PIC10F220/222 Rev. A Silicon Errata

The PIC10F220/222 parts you have received conform functionally to the Device Data Sheet (DS41270B), except for the anomalies described below.

PIC10F220/222 silicon Rev. A1. The A/D Converter does not meet the design target. The specifications listed below in Table 10-6 supersede Table 10-6 in DS41270B.

FIGURE 1: TYPICAL DNL AT 2.0V (TESTING AT 7-BIT LEVEL)

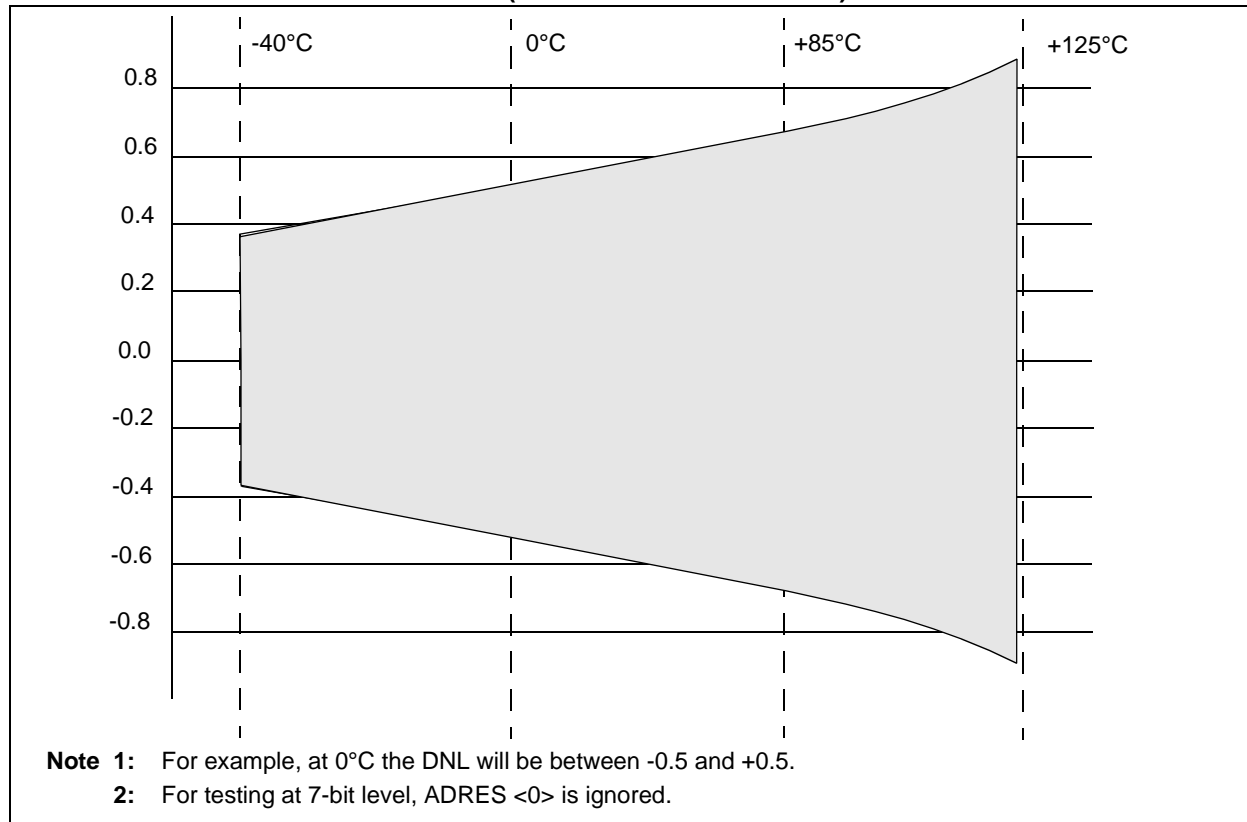
Note 1: This will be addressed in future silicon revisions.

Work around:

None.
